***TOWN COUNCIL***

**May 5, 2014**

**B. Preliminary Plat and Design Guidelines – Thompson Crossing II (TC Phase II, LLC):** *Chair Dowling opened the public hearing at 7:25 p.m. Town Planner Franklin introduced the application and presented the staff recommendation. Jim Birdsall, Birdsall Group, representing the applicant presented the request and answered questions. The applicant, and other consultants were also introduced. Matt Delich presented the traffic impact study.*

**TO:** Johnstown Planning and Zoning Commission  
**FROM:** John Franklin, AICP, Town Planner   
**DATE:** For March 12, 2014  
**SUBJECT:** Design Guidelines and Preliminary Plat – Thompson Crossing II

GRADING - NORTH EAST  
- PLAN -  
SCALE 1" = 50'

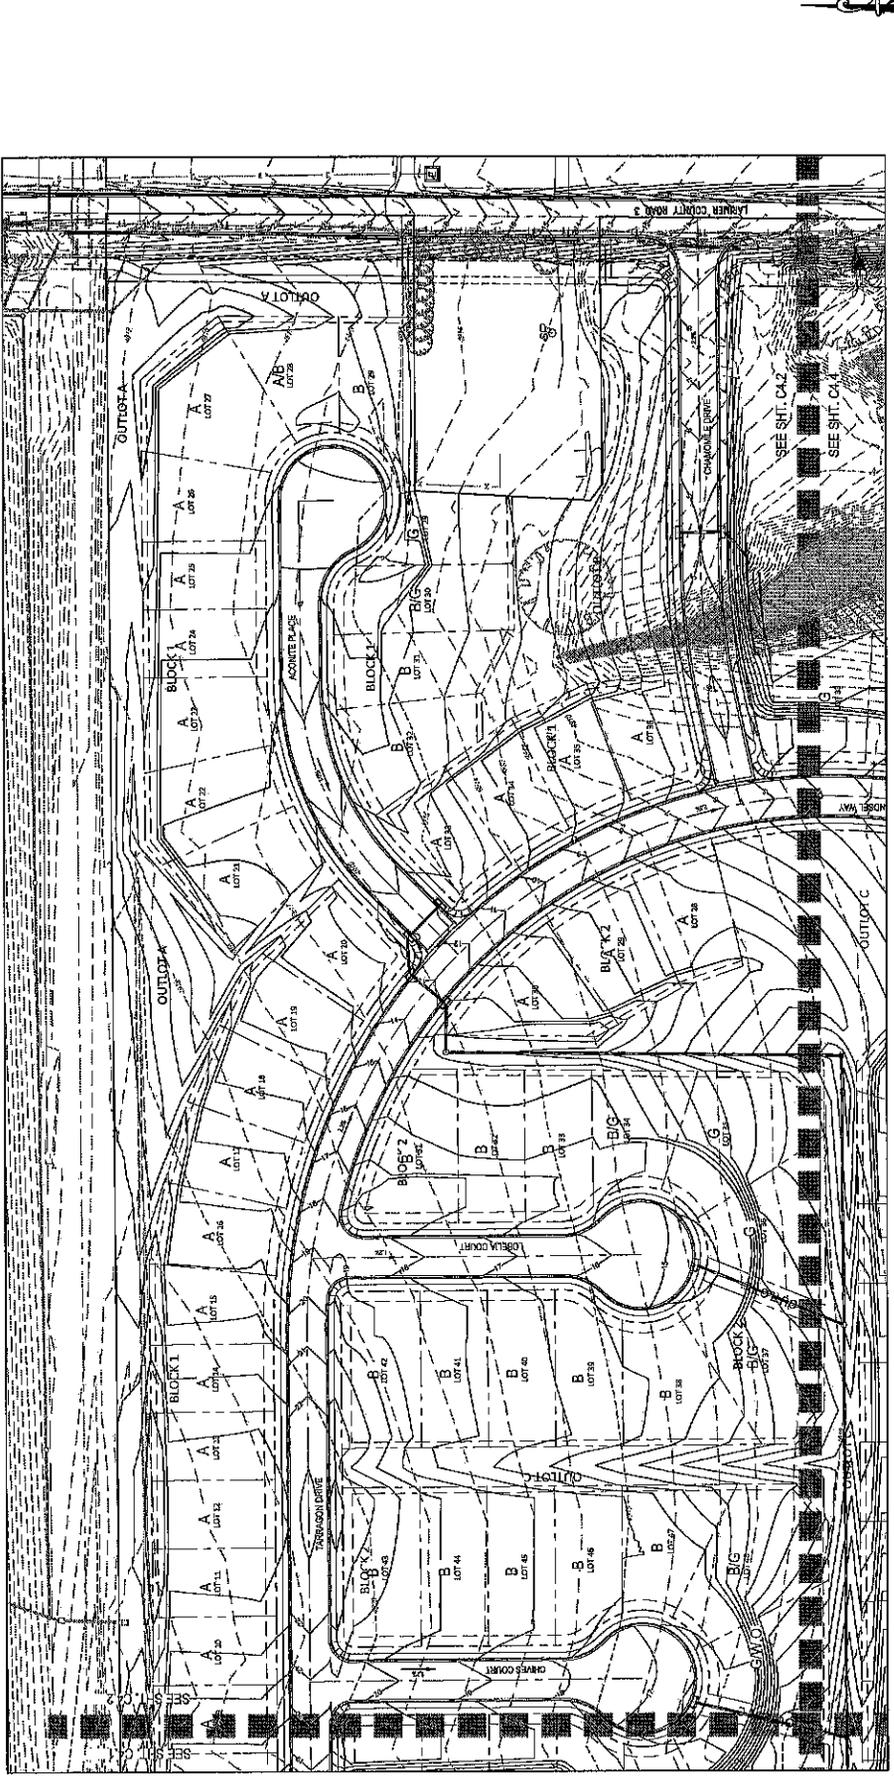
7. Please clarify the proposed width and material for the trail in Outlot E.
8. Sheet C4.2 – Per Comment 4 above, please revise the grading in the LCR 3 arterial ROW to eliminate the swale behind the curb and provide drainage over the curb into the storm sewer system.

GRADING - SOUTH EAST  
- PLAN -  
SCALE 1"=50'

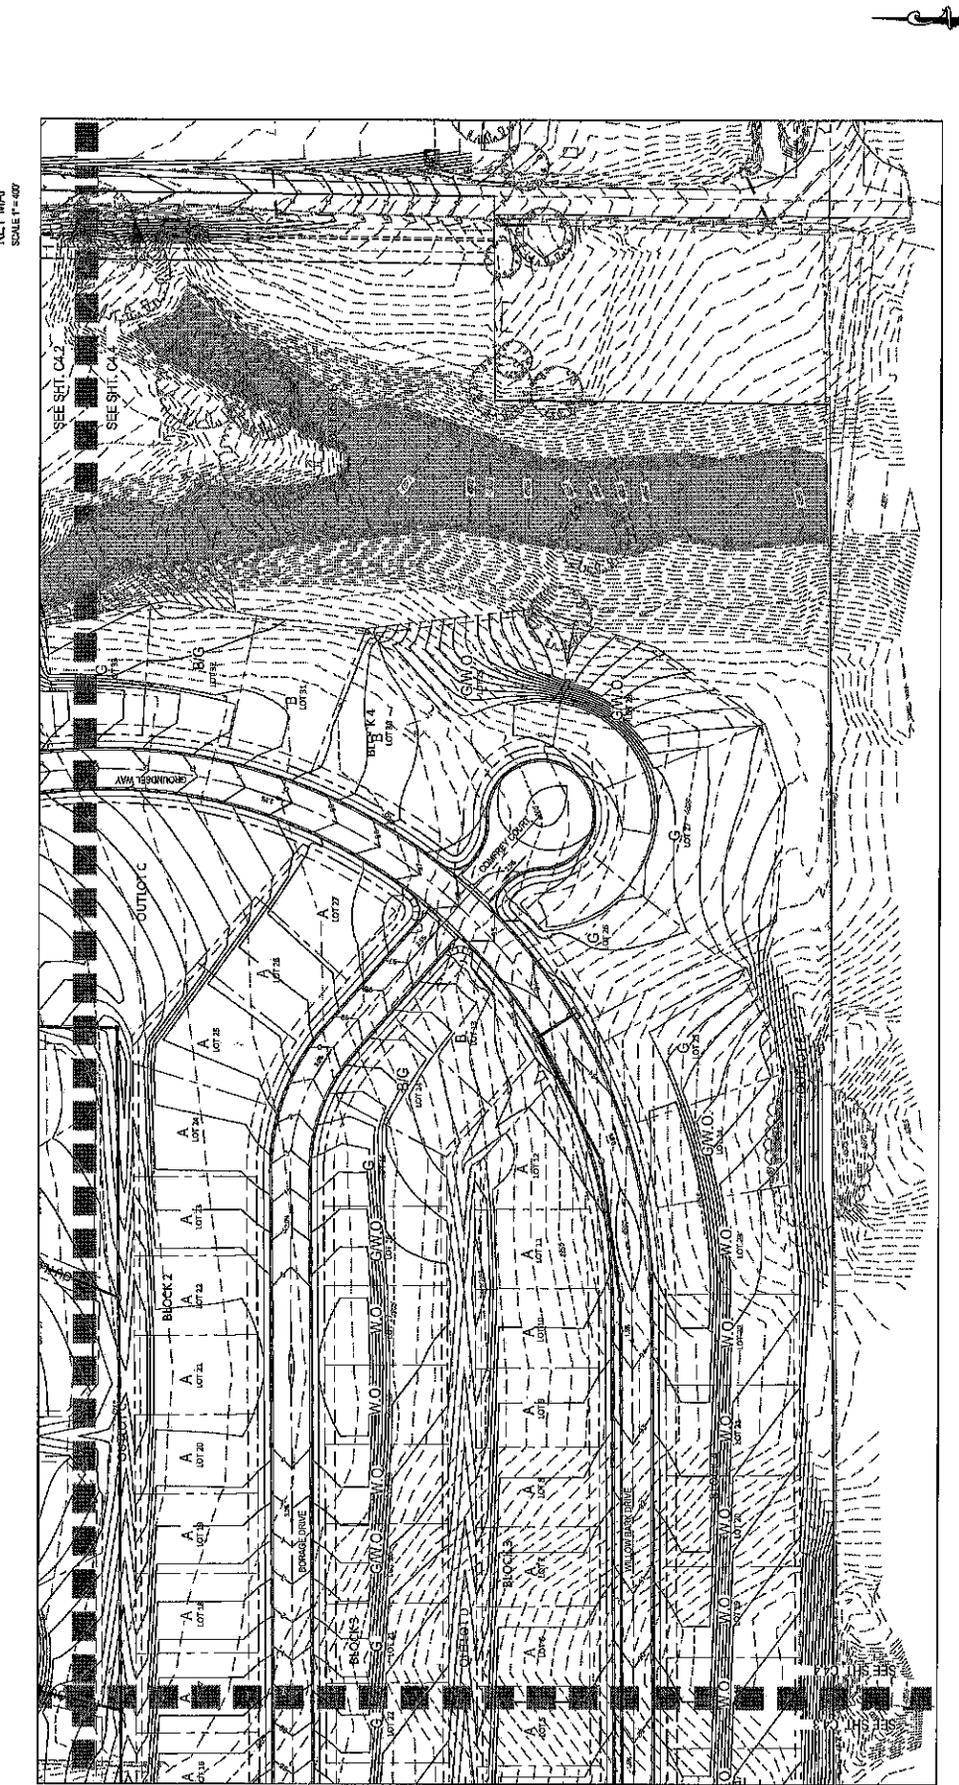
10. Sheet C4.4 - The grades southeast of Comfrey Court at Lot 28 and in the LCR 3 Arterial ROW are steeper than 3:1. Please revise the grades to meet the requirements of Section H.1.d of the current Town of Johnstown Landscape Standards and Specifications or add a wall to achieve the required grades.

LAB. NO. 60189215  
 DATE: 12/11/13  
 SHEET C3.0

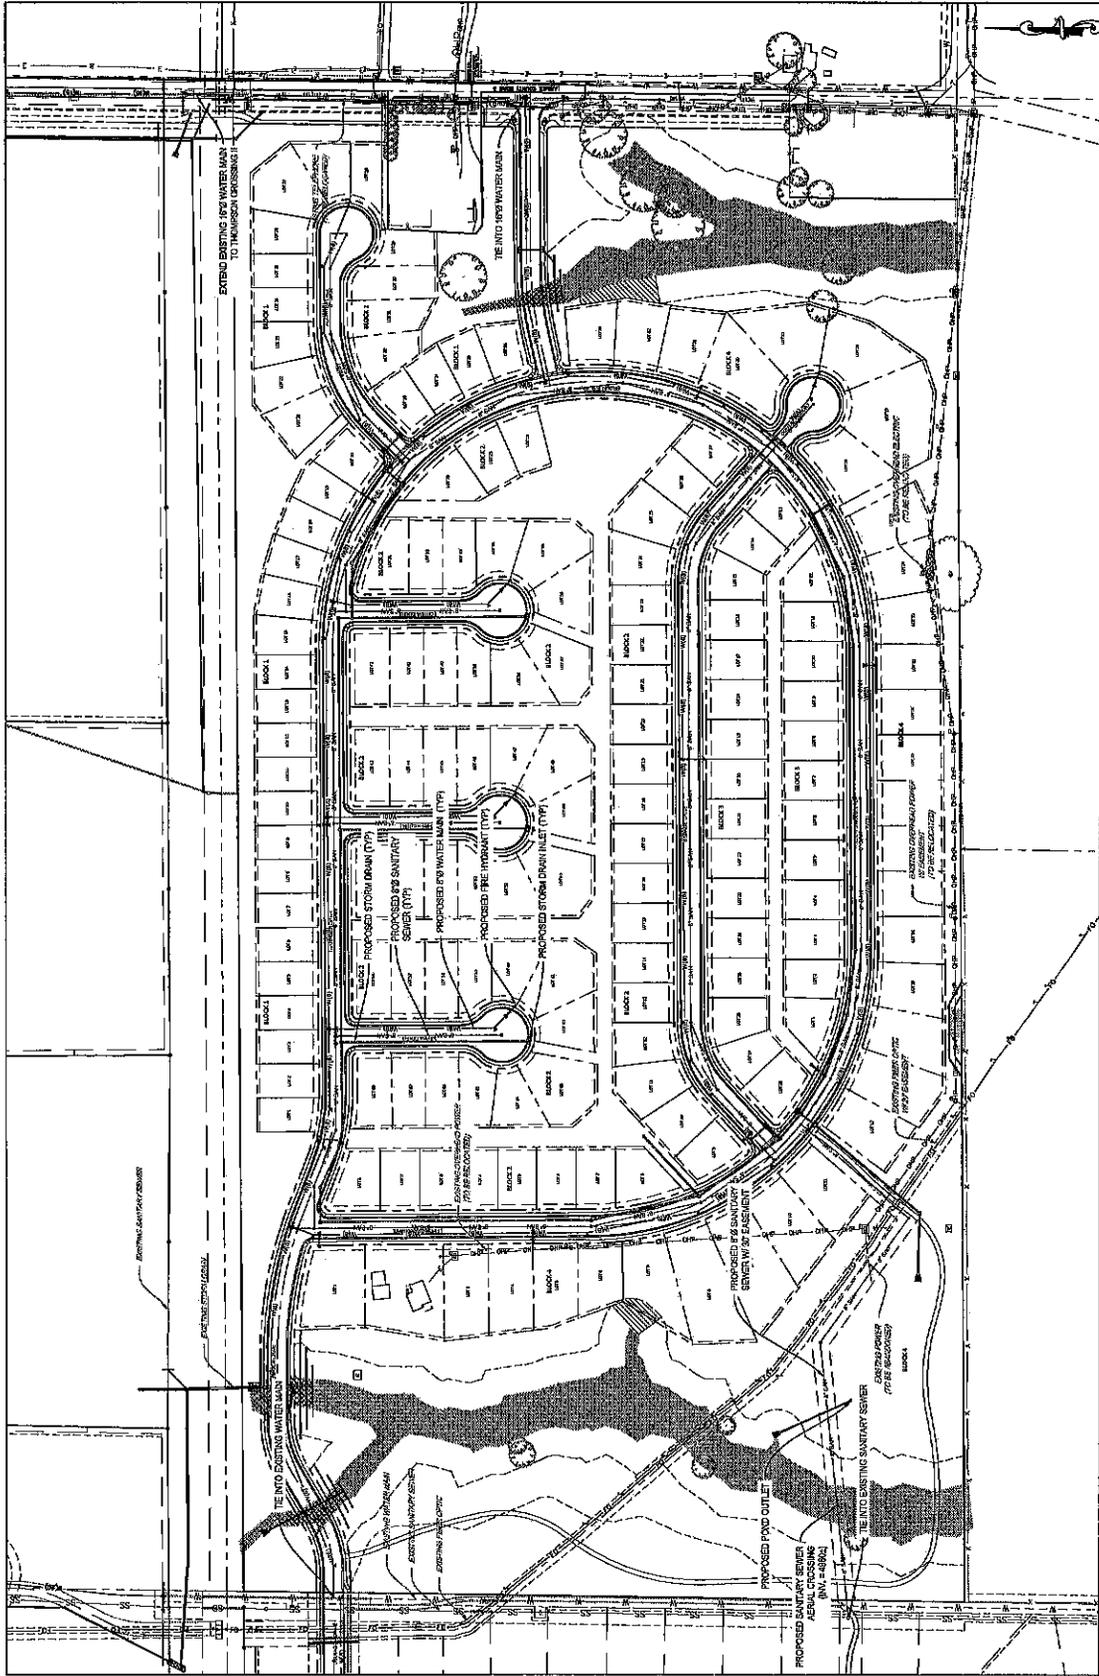
3. Sheet C3.0 – Utility Plan:
  - a. The storm sewer layout needs to be updated to incorporate the revised concept shown in the attached revised Sheet C3.0, as noted in the prior comments above.
  - b. A hydrant or appropriate water blow-off should be indicated at the south end of the proposed 16-inch water main extension along County Road #3.
4. Sheets C4.0 – C4.4 – Grading Plans:

1. Contingent on the understanding that the approved documents are based on the revised drainage plan (revised in-street storm sewers per revised Preliminary Plan Sheet C3.0).
2. Contingent upon final engineering approvals.

Enclosure: Revised Overall Utility Plan (showing revised storm sewer/drainage concept).
